Evaluation of proposed move for Water Right No 21810

Proposed: Move water right no. 21810 a distance of 2,080 ft to the west.

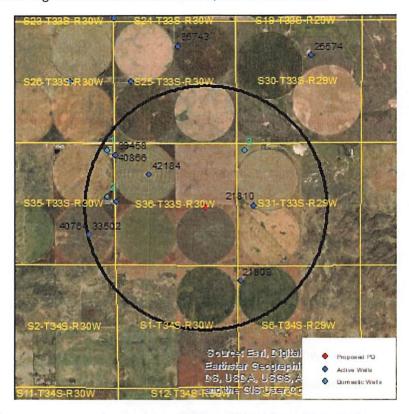
Wells within 1 mile: 42184, 39459 & 40865, 33502 & 40764, 21809, 39458 & 40866, and three domestic wells, numbered on the above map.
